# ELLCOTT SAND AND GRAVEL LLC - SITE DEVELOPMENT PLAN

## STAGE 1 OF 6 - EA#1881

EL PASO COUNTY DEVELOPMENT PLAN  
SITE DEVELOPMENT  
FOR  
SCHUBERT RANCH SAND RESOURCE  
ELLCOTT, COLORADO

FILE NAME:	1/6/2023
ESG-DR SITE PLAN	
SCALE:	AS NOTED
DRAWN BY:	EM/MS
CHECKED BY:	BH
ADD PCD FILE #	PPR-23-04

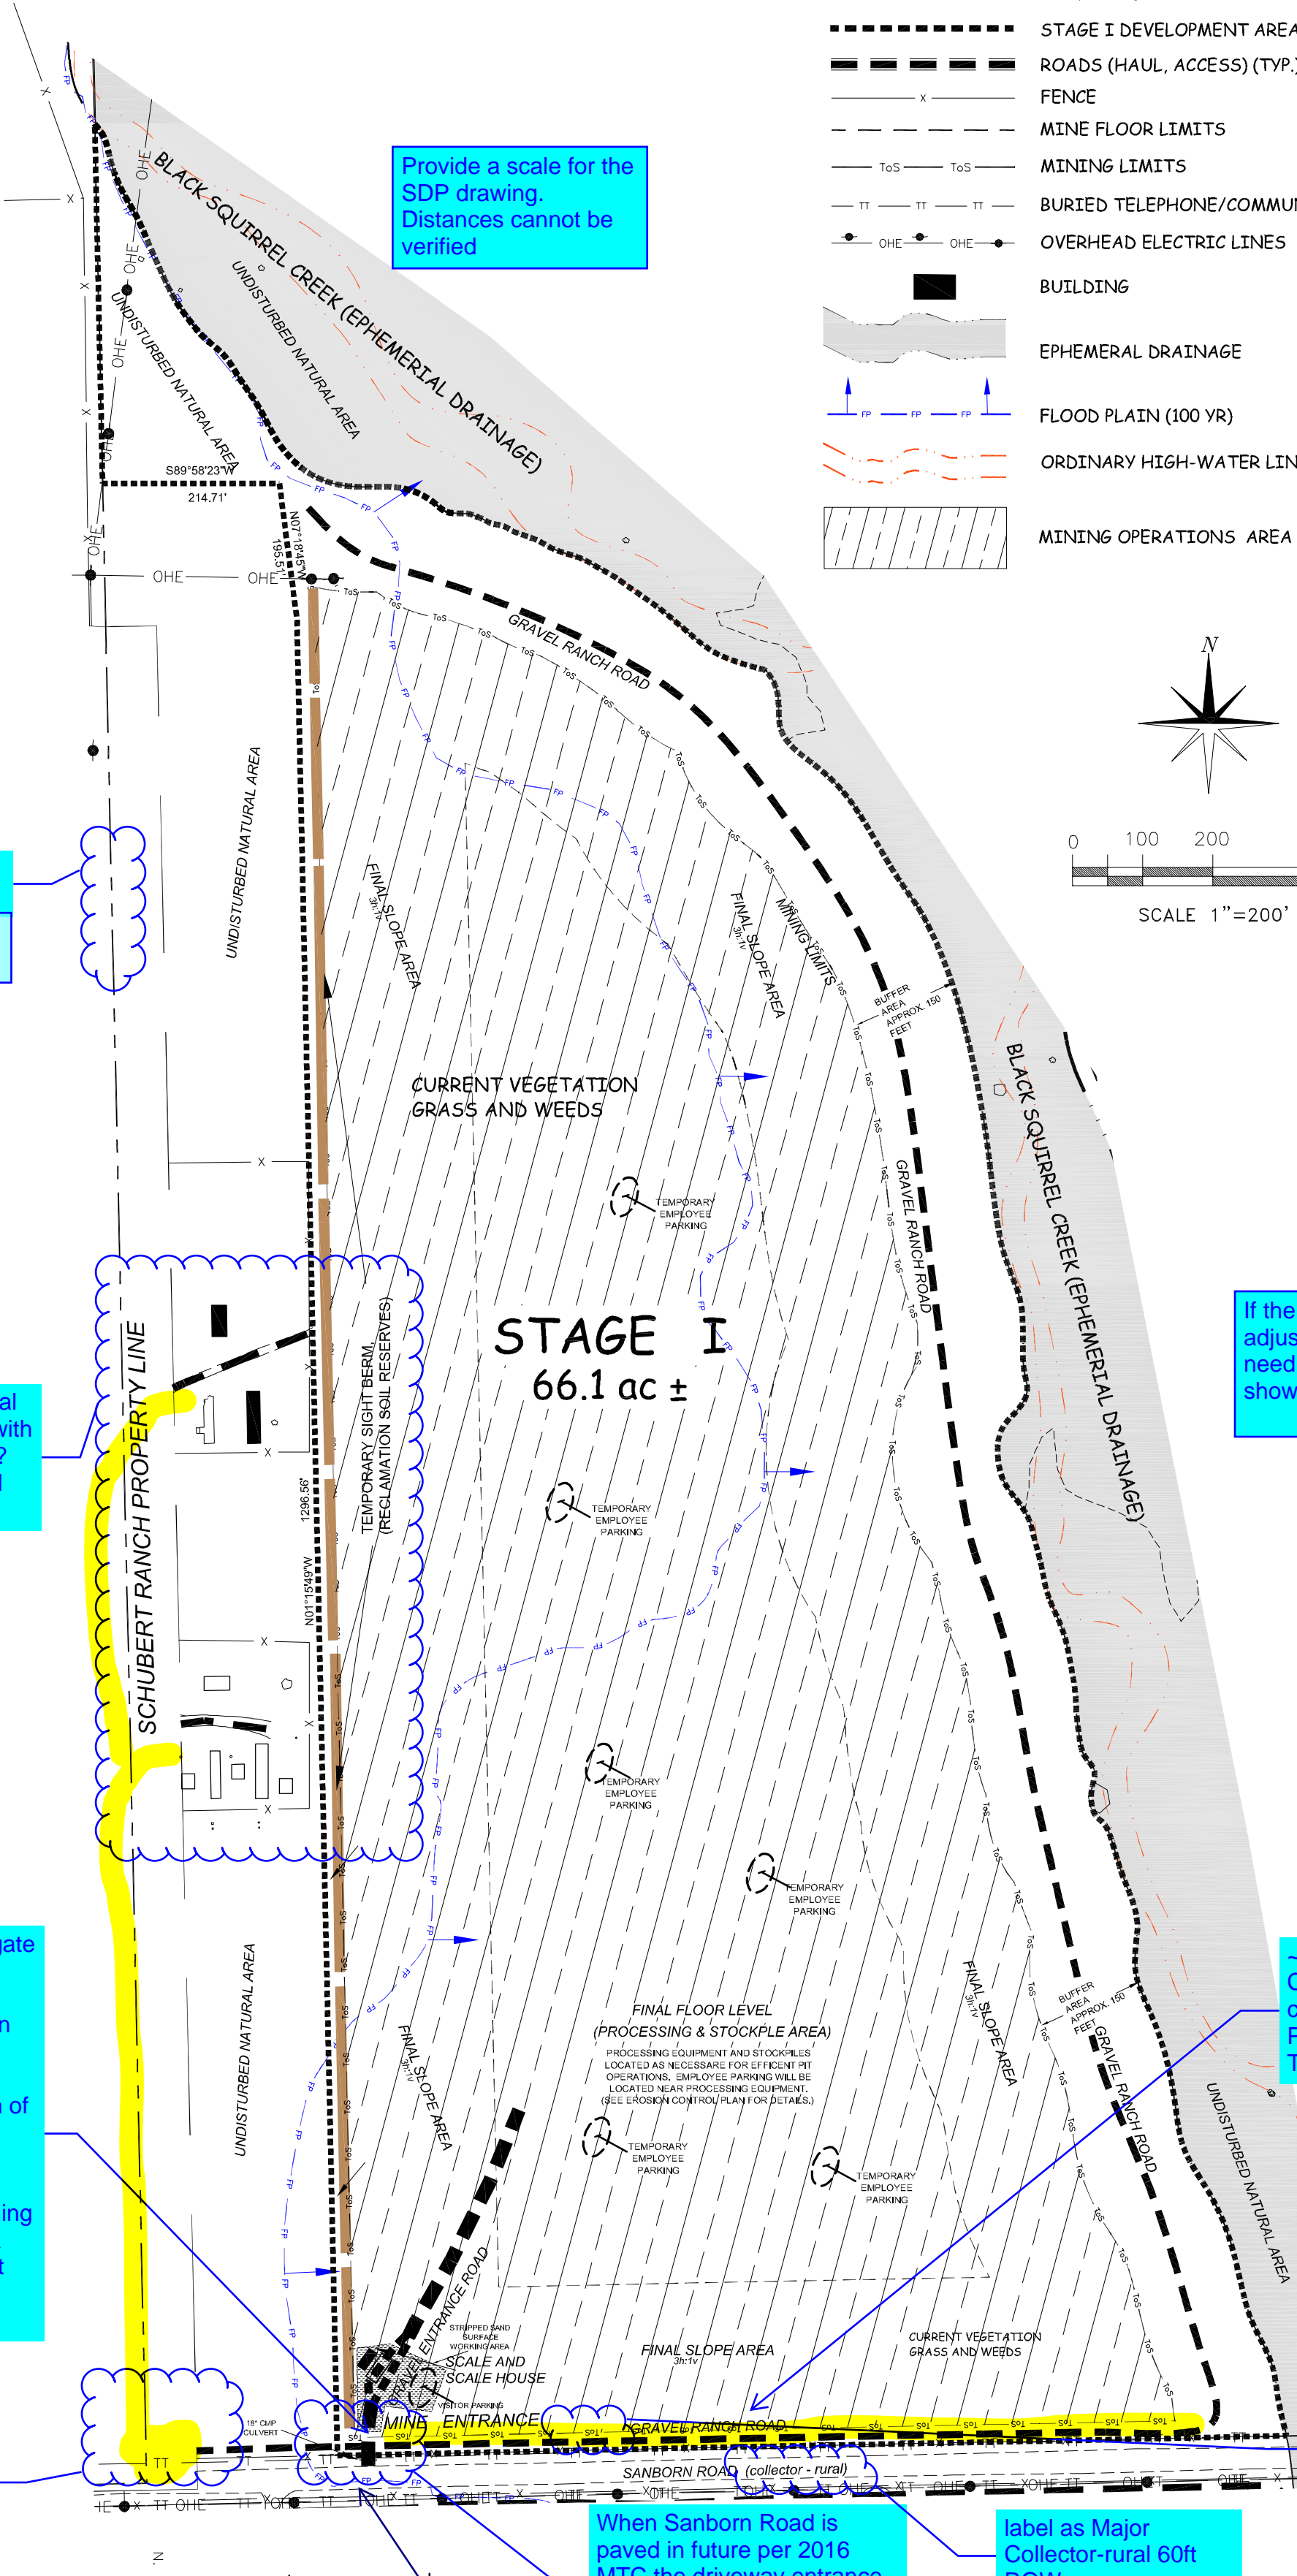
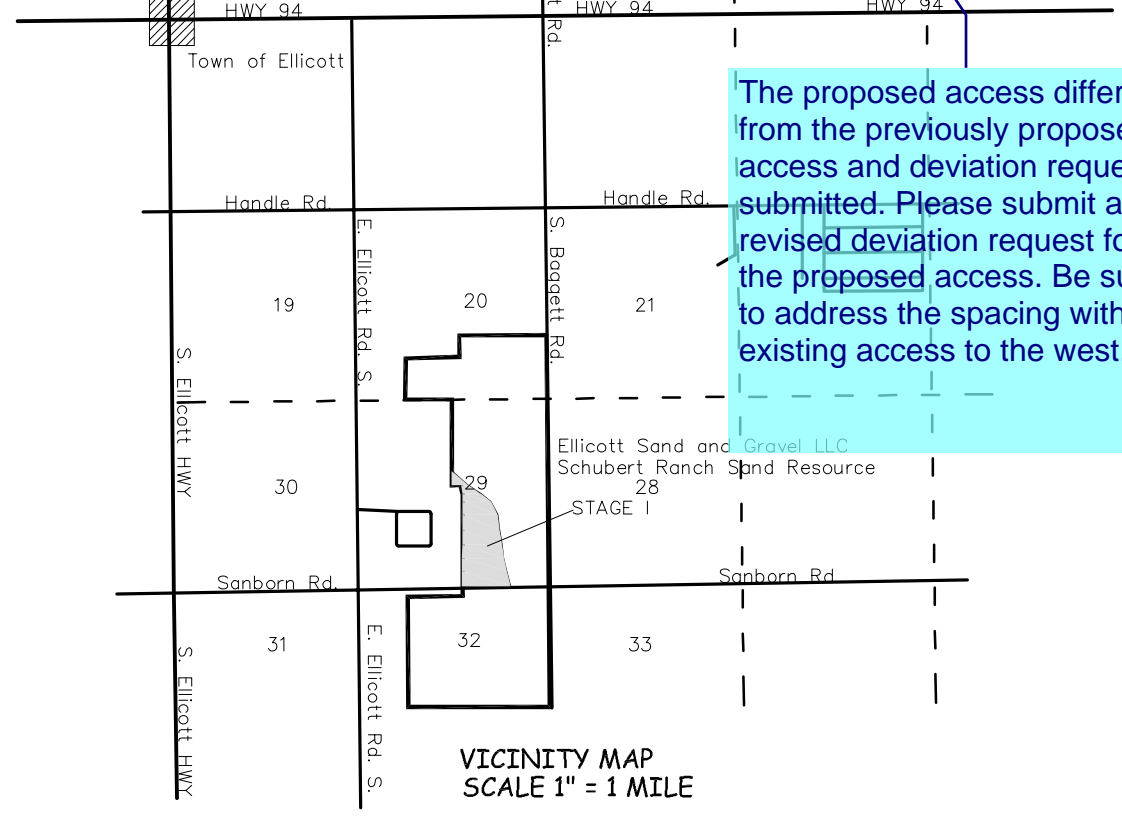
Provide a scale for the SDP drawing. Distances cannot be verified

Correct property line to match legend. make it bold as shown on the legend

Are these residential properties/homes with a driveway access? Provide details and label homes

Provide entrance gate location detail with setback per LDC 6.3.3 Gate Location and Dimensions. Gates shall be located a minimum of 30 feet from the public right-of-way and shall not open outward. The opening provided through a gate shall be 2 feet wider than the traveled way.

Show and label this additional driveway access. Access spacing not met per ECM 2.4.1. Provide deviation or close driveway access

The proposed access differs from the previously proposed access and deviation request submitted. Please submit a revised deviation request for the proposed access. Be sure to address the spacing with existing access to the west.

When Sanborn Road is paved in future per 2016 MTC the driveway entrance will be required to be paved 50ft inward.

label as Major Collector-rural 60ft ROW

Additional setback and buffer from Sanborn and roadside ditches will be required from the mining limits. Sanborn road planned for improvements per 2016 MTC as a paved major collector with a 90ft ROW. Adjust Mining limit demarcation line further back to match GEC Plan which denotes undisturbed area.

~150ft setback buffer. Correct SDP to coincide with GEC Plan. Correct mining ToS limit line

If the haul route is adjusted then map will need to be corrected to show Baggett Rd.
